Detailed Site Plan
Departure from Design Standards
Alternative Compliance
Dash In at Marlboro Pike #1552

DSP-21009
DDS-687
AC-21022

SUBJECT: Detailed Site Plan DSP-21009
Departure from Design Standards DDS-687
Alternative Compliance AC-21022
Dash in at Marlboro Pike

Figure 1: Site Plan

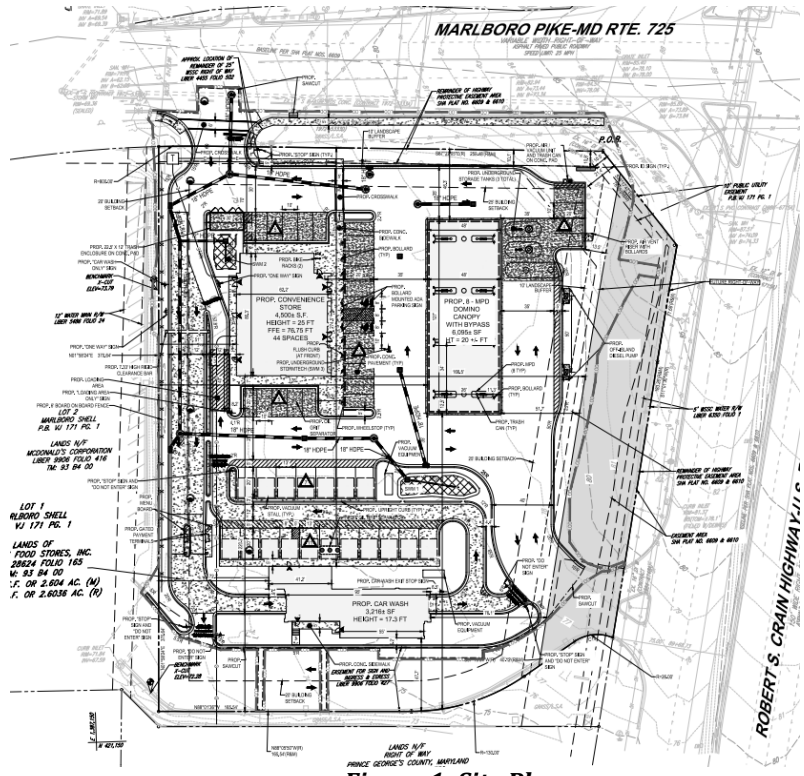
- a. Revise the bearing for the western property line shown on the DSP to match the record plat.
 - b. Revise the height of the proposed freestanding pylon sign to 25 feet or revise the sign detail to reflect that there are three fuel types being proposed to meet the 50-foot height requirement.

- c. Revise the sign legend to correspond to the signs on the site plan. Provide the same labeling convention for both the legend and the plan.
 - d. Label the area of Lot 1 on Sheet 4 of the DSP in square feet and acres.

- e. Modify the site to expand the designated loading area, in order to facilitate safe and adequate truck turning maneuvers. The exact design and truck turning plans with design vehicle classification shall be evaluated and accepted by the Transportation Planning Section.

- g. Provide the exact dimensions of the buildings on the site plan.

- h. Add the street connection width for MD 725 (Marlboro Pike) to the site plan.
- i. Revise the landscape plan to conform to Section 4.3 by removing one parking space to the east of the food and beverage store, widening the planting islands five feet, and adding a shade tree to each island.
